**FERGANA VALLEY
CANAL AUTOMATION PROJECT**

**REPORT OF THE THIRD MISSION
OF INTERNATIONAL EXPERTS**

May 10-27, 2008

Figure 3: Variations of the level at BFC head works on Naryn River over a 2-day period

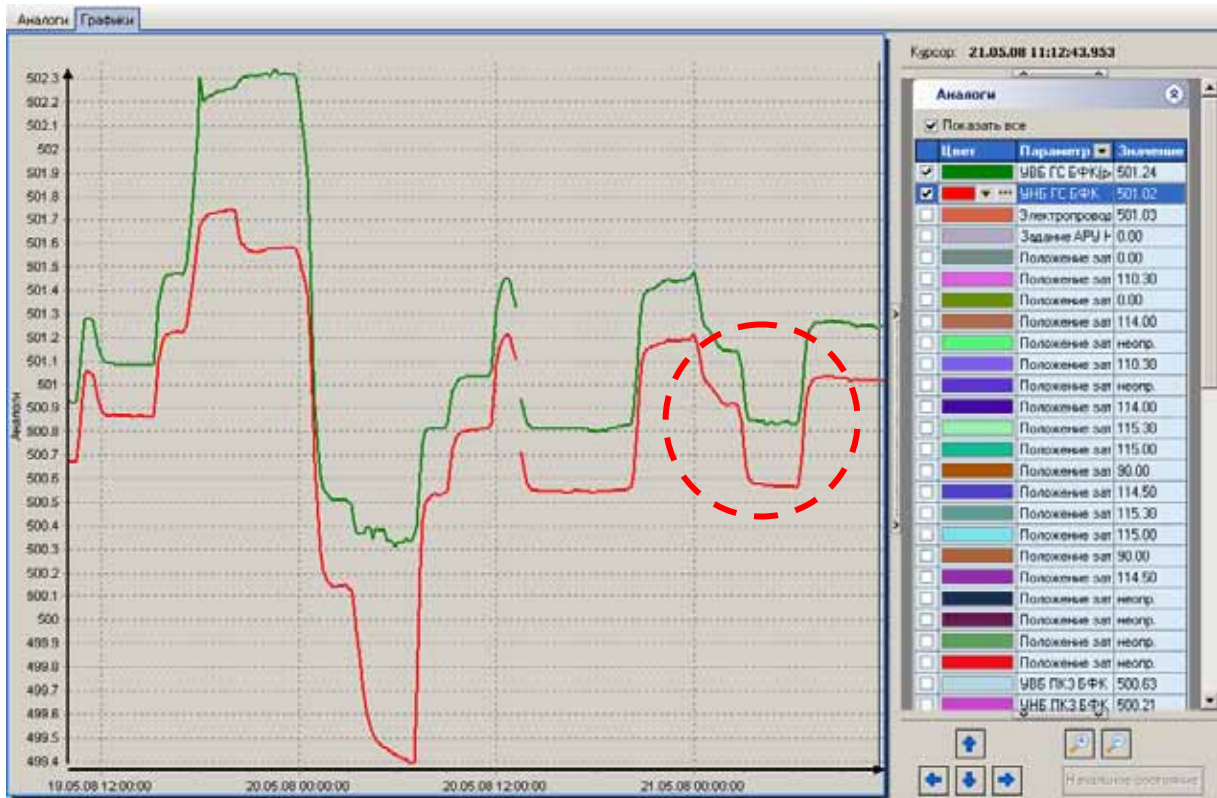
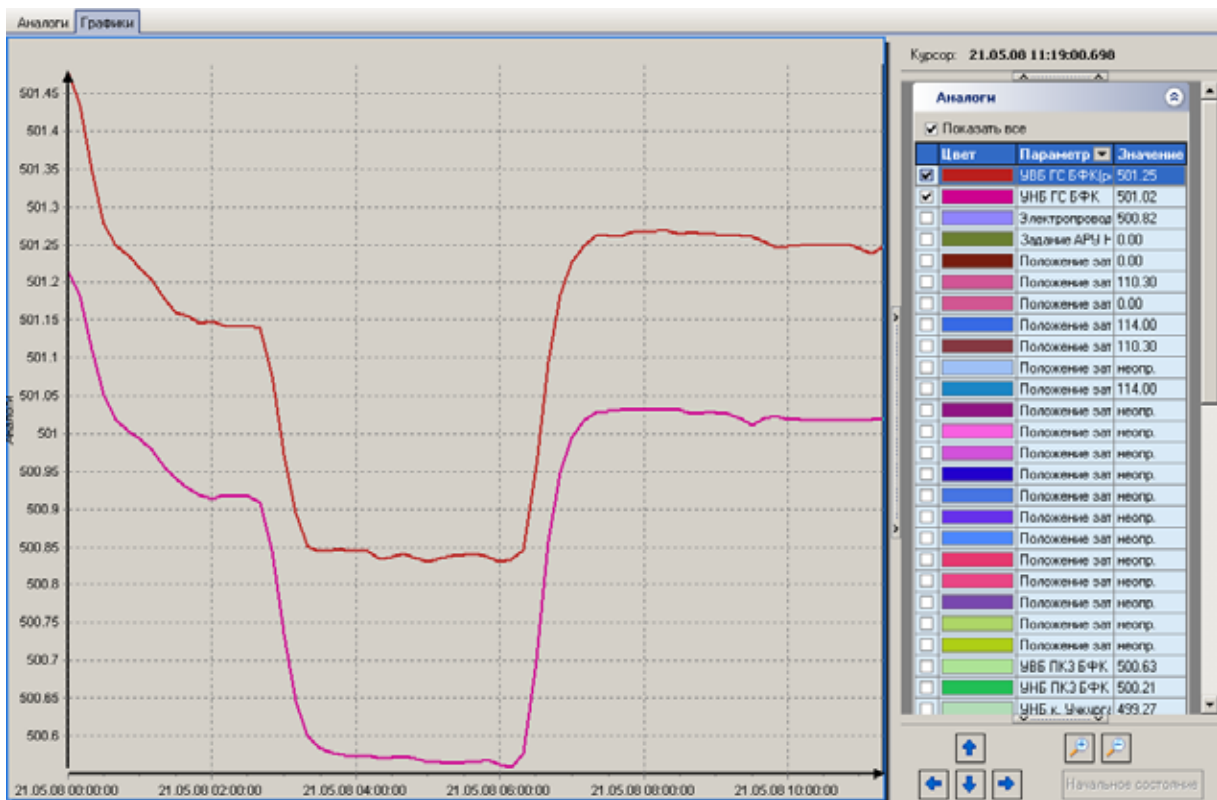
- 1) Important variations of the level of Naryn river: large variations of the level of the Naryn River are observed on a daily basis (see Figure 3 and Figure 4 in Appendix). This problem was not felt with such importance in earlier years. As a consequence, the automatic regulation mode of the BFC head works cannot be used when the level is too low. Moreover, water can drop to a level too low to be measured by the ultrasonic level sensor located upstream of BFC head works. In these conditions level measurements have to be performed manually.

Figure 6: Results of discharge test at DP66

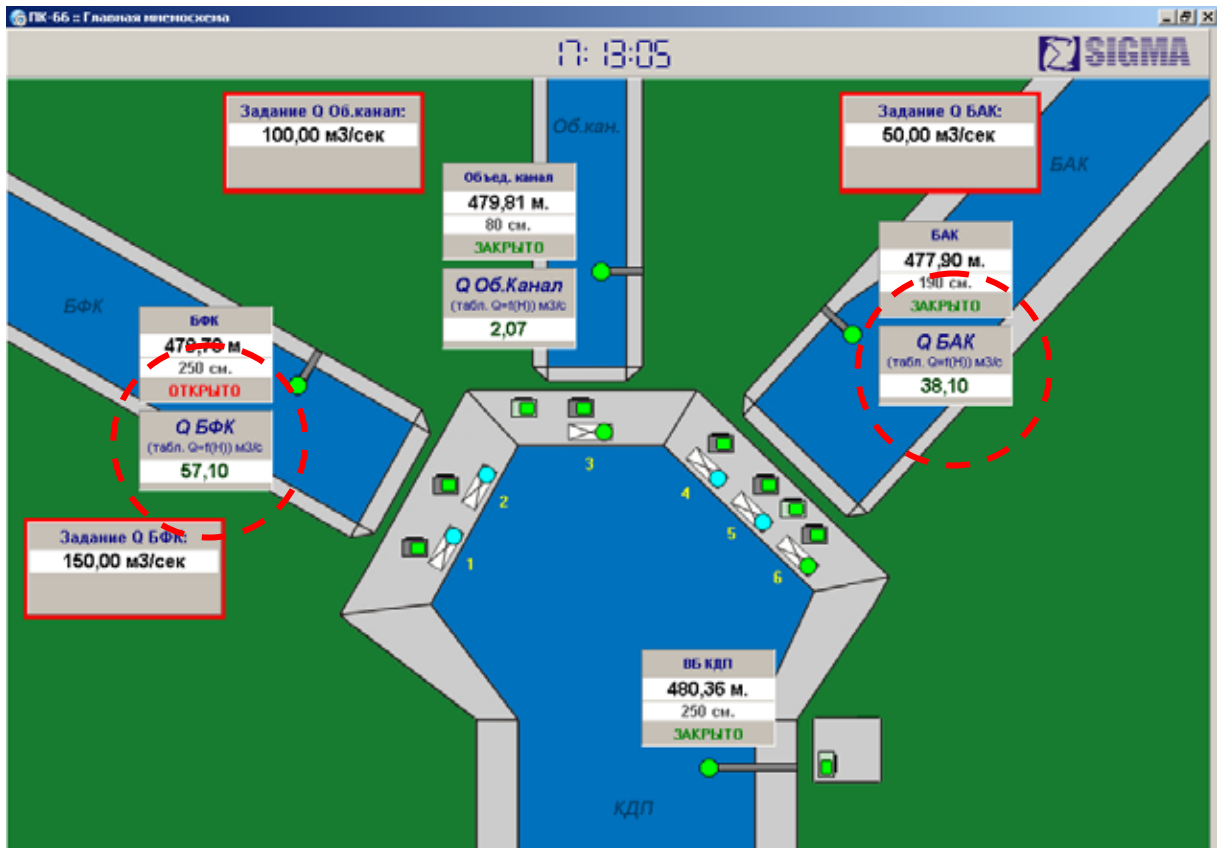
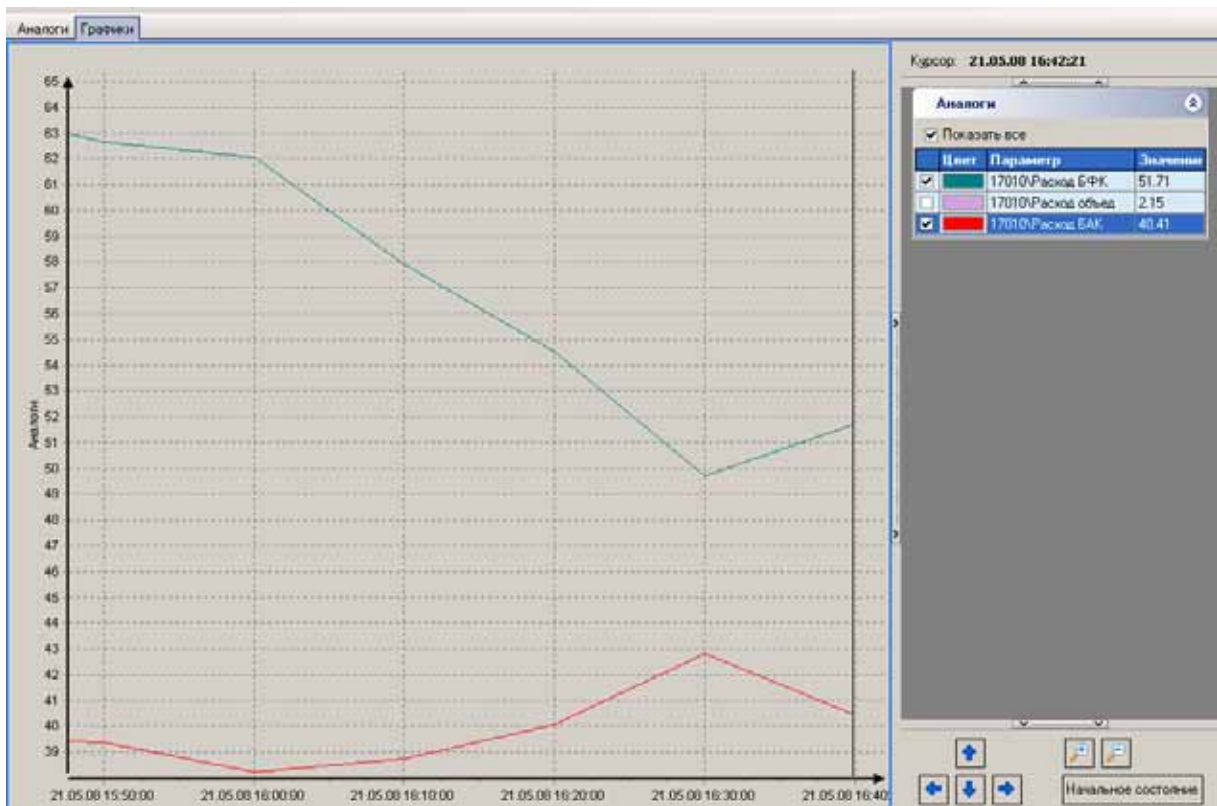
Test of control of gates from SCADA system: At DP15, a test was performed consisting in reducing the offtake discharge from 14,3 to 13 m³/s. Another test was performed at DP66: discharge on BFC was reduced and discharge on BAC was increased of the same value (see Figure 6). Both tests gave the expected result and control of gates seems to be operating properly.

Figure 8 Head Work Screen Display

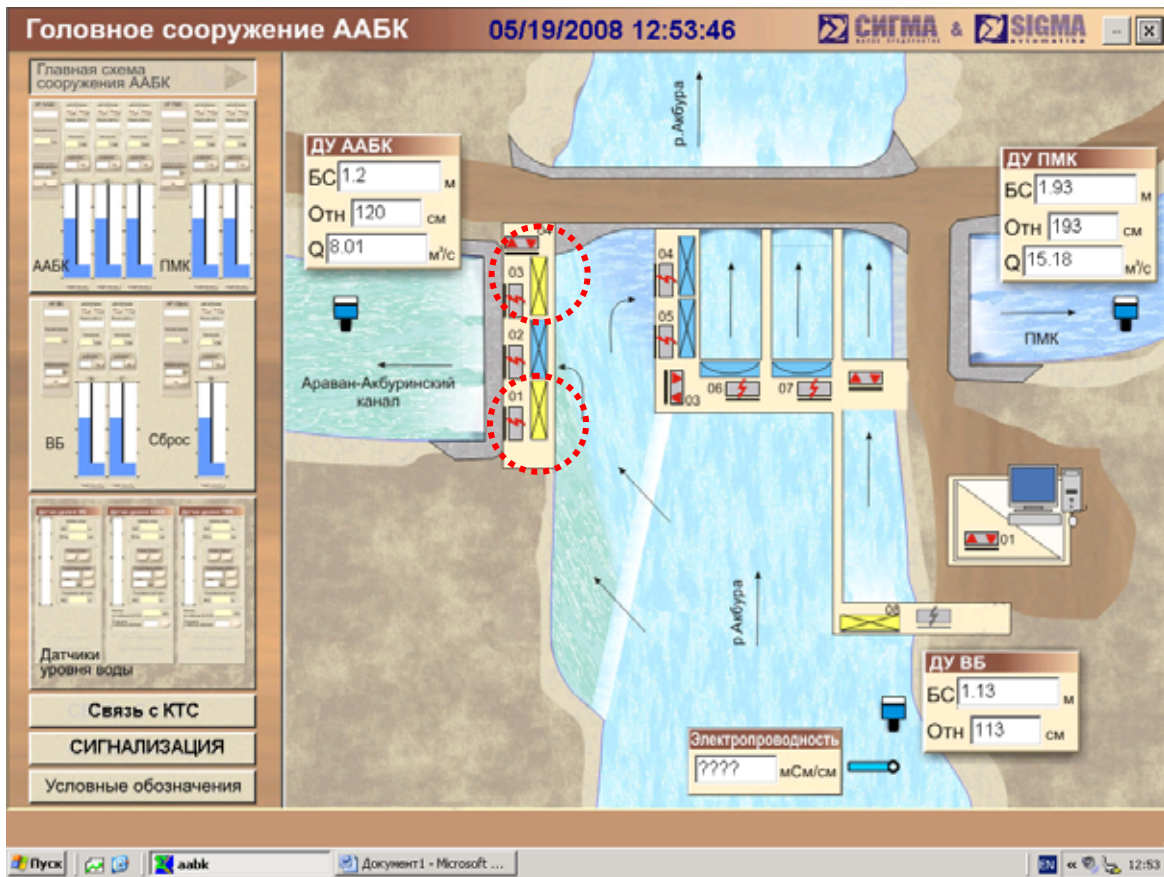
In all automated structures, motorization of gates was working, except at the head work of AABC on Akbura River where two out of three of gates supplying the AABC were not working (see Figure 8).

The two dotted circles indicate the gates which can only be operated manually.

- The two gates of AABC head work which are not working must be repaired, and actions for avoiding such default have to be taken. Regular maintenance of all equipments must be done. The best solution is to have a contract with a private company, as it was done with SIGMA on BWO structures.
- Actions have to be taken for avoiding loss of data in case of power cut. It is recommended to install a backup power supply, either by diesel generator or by solar panels and batteries; only measurements and data transmission have to be backed up and require limited power.
- It is recommended to extend the assistance of SIC and SIGMA to AABC to provide an efficient on-the-job training to the operators; an additional session of practical training could also be organized on site as quickly as possible.
